ADDENDUM NO. 1

TO: All Holders of Plans and Contract
Documents for the Swisher Road Bridge
No. 3100000 Replacement, BRO-B080 (037)
Pettis County, Missouri

ISSUED: August 05, 2020

RAIL POST AT BENT

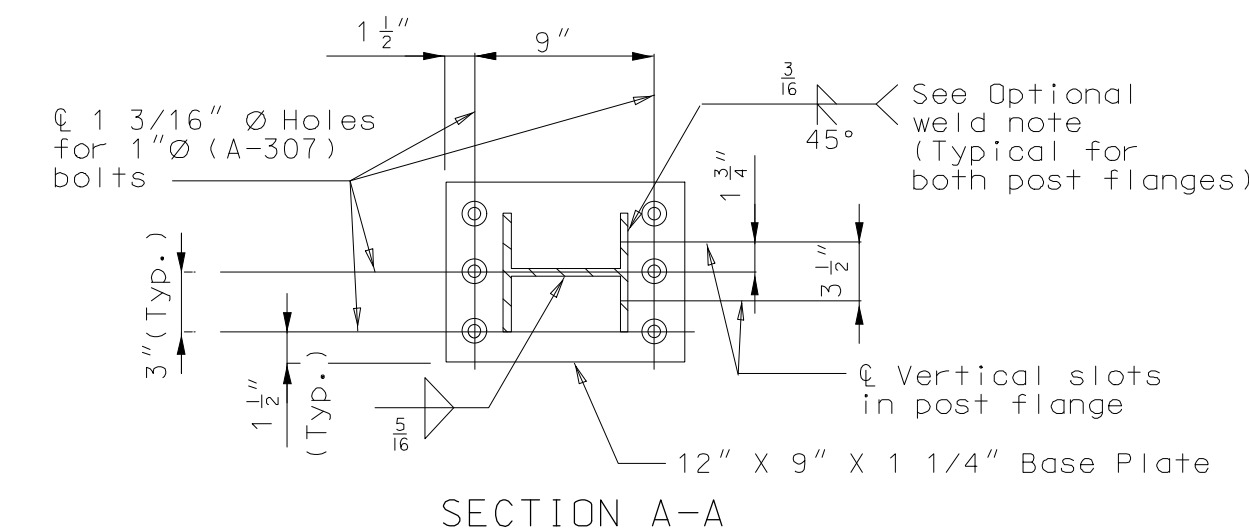
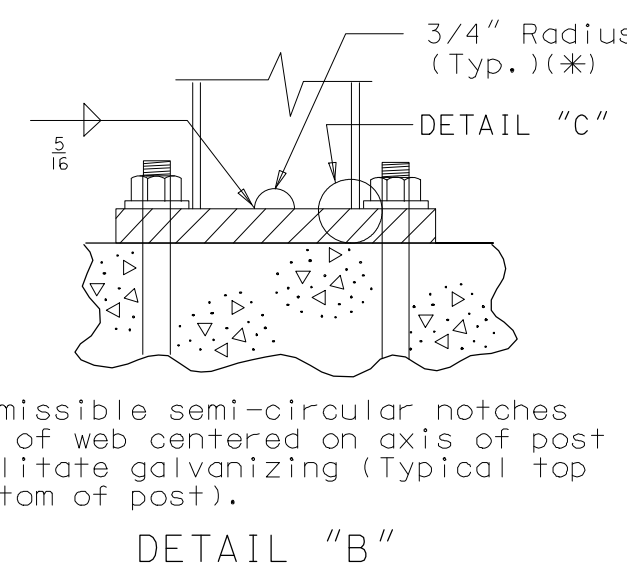
- 1) Plan Sheet 18 - Omitted C8x11.5 Cap Rail on top of the post.

DRAWING INFO.		REVIEWS		FIELD INFO.	
NO.	DESCRIPTION	BY	DATE	FIELD BY:	FIELD DATE:
1	ADDENDUM #1 (REMOVE CAP RAIL)	CAW	7/27/2020	CAW	8/7/2019
				GDS	
				DATE:	8/7/2019
				FIELD BOOK:	
				JOB NUMBER:	19KCT0003
